PLANT NAME: Three Mile Island #1

Three Mile Island Nuclear Station Unit 1 (TMI-1)  
Docket No. 50-289  
Operating License No. DPR-50

Responses to Nuclear Regulatory Commission (NRC) Questions  
Regarding TMI-1 Technical Specification Change Request No. 9

Appendix I  
TMI-1  
CONTROL ROD POSITION LIMITS AFTER CONTROL  
ROD INTERCHANGE

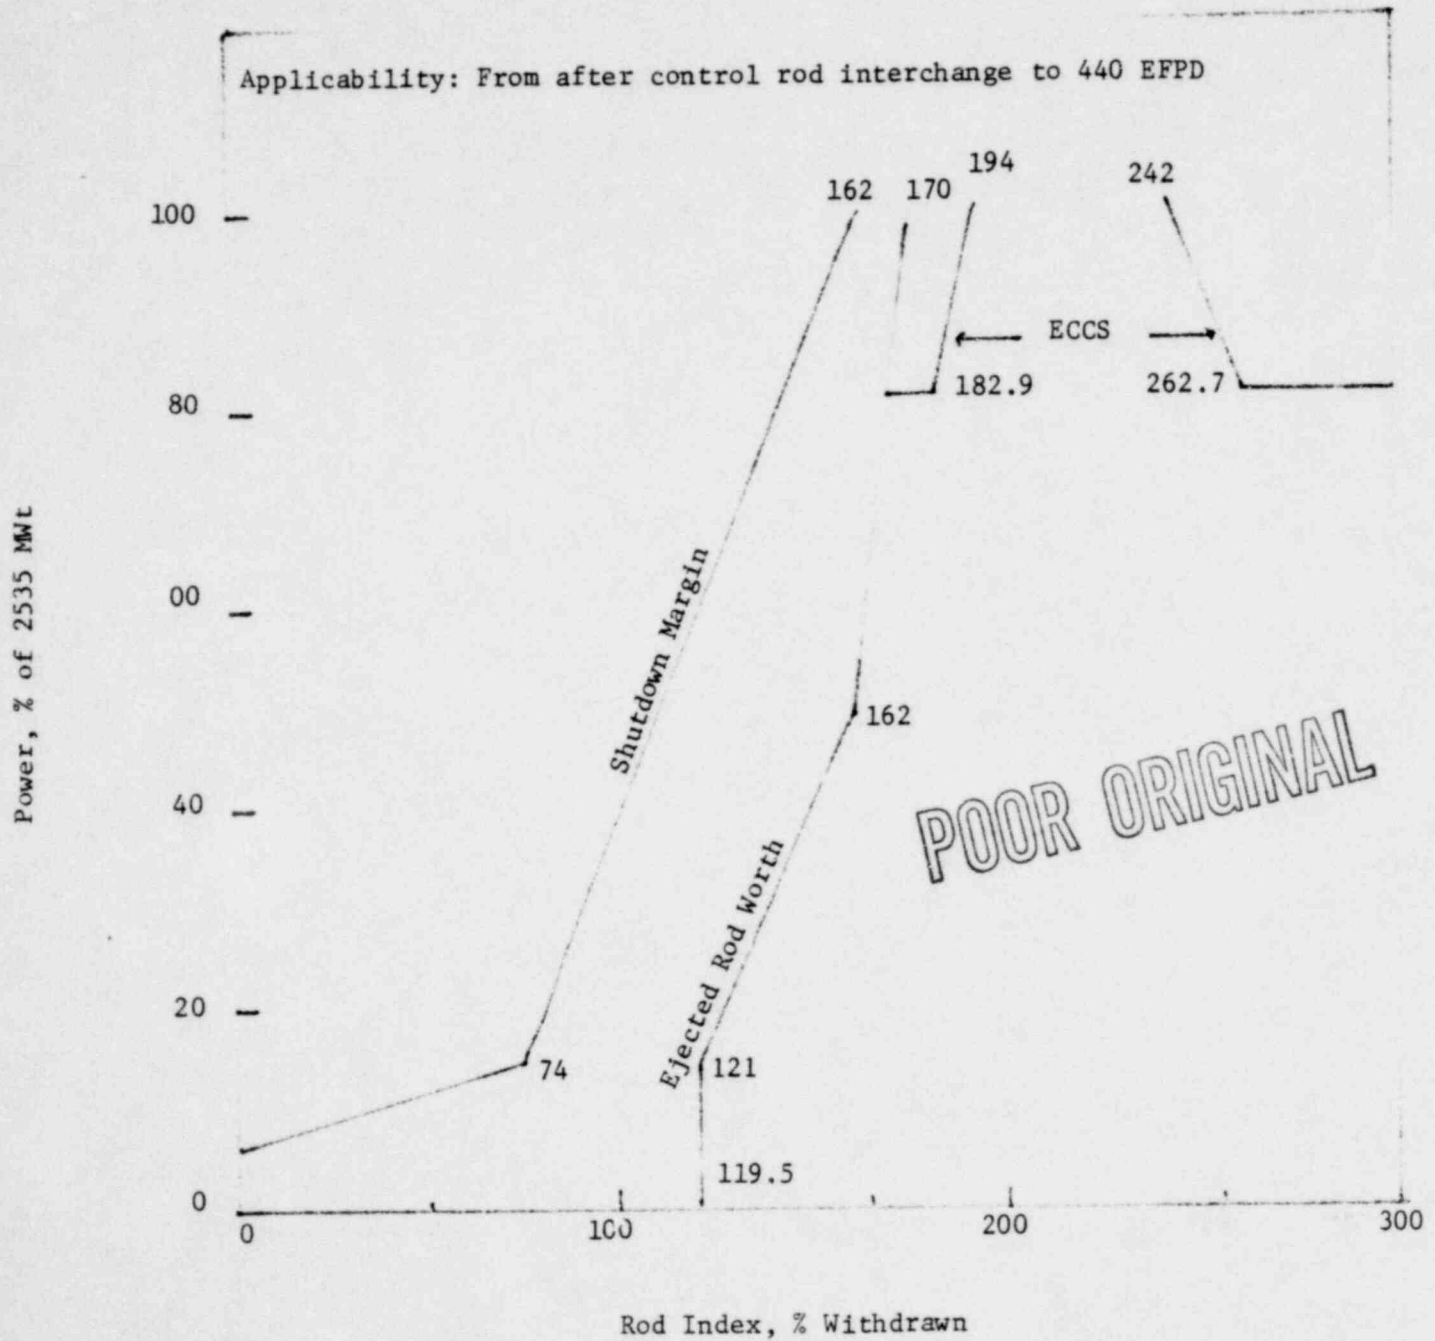
The Rod Group Withdrawal Limit Curves under consideration consist of the most restrictive envelope of the Interim Acceptance Criteria, the additional operating restrictions furnished to you via the Order for Modification of License dated December 27, 1974 and your proposed Technical Specification change dated April 16, 1975. For this envelope, please indicate the maximum ejected control rod worth and the power at which it occurs for the conditions represented in Figures 3.5-2A, 3.5-2B, 3.5-2C, and 3.5-2D of your application.

Focusing now on the Technical Specification Change Request in question (i.e. No. 9), please refer to the attached Appendix I, which presents the acceptable power vs. rod withdrawal operating regions for the three criteria upon which the limits of the change request are based. As noted in Appendix I, these criteria are as follows:

1. to maintain the ability to achieve a  $\geq 1\%$  shutdown margin,
2. to remain within the applicable peaking limit as defined by the Interim Acceptance Criteria (denoted in Appendix I by "ECCS"), and

3. to remain within the applicable potential ejected rod worth limits.

As can be seen from Appendix I, the power vs. rod withdrawal limits as contained in Technical Specification Change Request No. 9 consist of the most restrictive of the 3 above criteria. In that the criteria that is in question is that which relates to ejected rod worths, the remainder of the response to question number 1 will be directed to this area.

Operating within the ejected rod worth power vs. rod withdrawal limit curve of Appendix I assures--for the time period referenced on the figure--not exceeding (1) the required ejected rod worth limits of 1%  $\Delta K/K$  at hot zero power, and .65%  $\Delta K/K$  at rated power; and (2) assumed ejected rod worth limits between these two power levels (note: these assumed limits are derived by considering the applicable ejected rod worth limit to be a linear function of power between 0 and 100%. As an example, therefore, operating to the right of the Appendix I ejected rod worth power vs. rod withdrawal curve at 50% power would ensure not exceeding an ejected rod worth of .825%  $\Delta K/K$  (i.e.  $1\% - .5(1 - .65\%) = 1\% - .175\% = .825\%$ )).

In response to the NRC question No. 1, it should be noted, however, that additional degrees of conservatism were included within the analyses (i.e. a 10% degree of conservatism for Figure 3.5-2A, and a 15% degree of conservatism for Figures 3.5-2B, 2C and 2D). In response to the question, therefore, the calculated maximum ejected rod worths for the conditions represented in Figures 3.5-2A, 2B, 2C, and 2D all occur at hot zero power as follows:

<u>Figure</u>	<u>Max. Ejected Rod Worth</u>	<u>Burnup EFPD</u>
3.5-2A	.90	253 + 10
3.5-2B	.85	440
3.5-2C	.85	466
3.5-2D	.85	466

# APPENDIX II

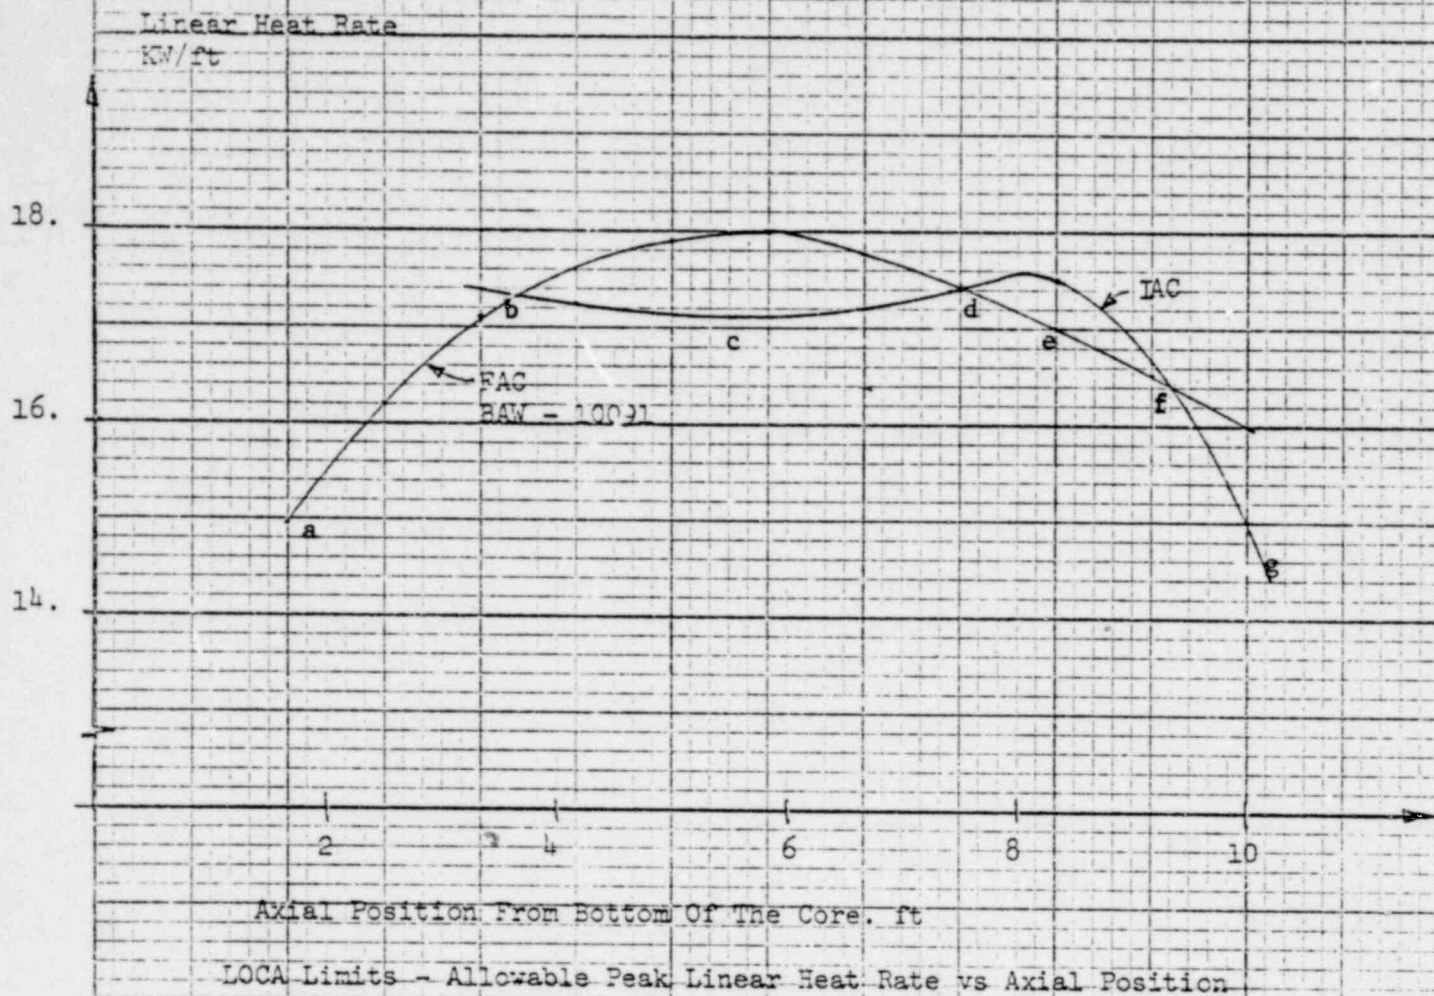
Provide a figure (Peak Linear Heat Rate, KW/ft versus Elevation from Bottom of Core, feet) which shows (a) the LOCA limit curve of BAW-10091, (b) the maximum operating peaks which are permitted under your present Technical Specification including the December 27, 1974 Order for Modification of License and (c) the maximum operating peaks which result from the envelope referenced in (1) above.

- a. LOCA Limit Curve of BAW 10091: Submitted on September 5, 1974, as figure 3.5-2F of TMI-1 Technical Specification Change Request No. 4; figure has been reproduced and included with this submittal, and is denoted by "FAC" in Appendix II.

- b.
  1. Present Technical Specification Limits: Consist of those as represented by the current TMI-1 Technical Specification Figure 3.5-2E; figure has been reproduced and included with this submittal, and is denoted by "IAC" in Appendix II.

2. December 27, 1974 Order for Modification of License Limits: Imposed the most restrictive of the limits of a. and b.1. above, and is shown by the continuous line designated a. b. c. d. e. f. g. in Appendix II; had been previously implemented by Licensee on August 5, 1974; and is implemented through administrative controls, which require conformance to the most restrictive of the IAC and FAC based power vs. rod withdrawal limit curves.

It should first be noted that Licensee maintains that none of the ejected rod worth limit curves has any bearing on the subject maximum KW/ft operating peaks and that previous submittals in this subject area should provide adequate assurance that the combined limit curve of Appendix II is not exceeded. Reasons for having made this statement are as follows:

- a. the subject KW/ft peaks are primarily a function of fuel loading, core burn-up, rod position, and power level (and not ejected rod worths),
- b. there is no reason to suspect that the fuel loading and core burn-up analyses are in error,
- c. the (power level, rod withdrawal) coordinates utilized in ensuring that the maximum KW/ft peaks are not exceeded were derived from the ECCS portion of the envelope shown in Appendix I, and
- d. utilization of the (power level, rod withdrawal) coordinates represented by the ejected rod worth limit curve would result in even less severe KW/ft peaks as those derived from utilization of the coordinates described in c. above.
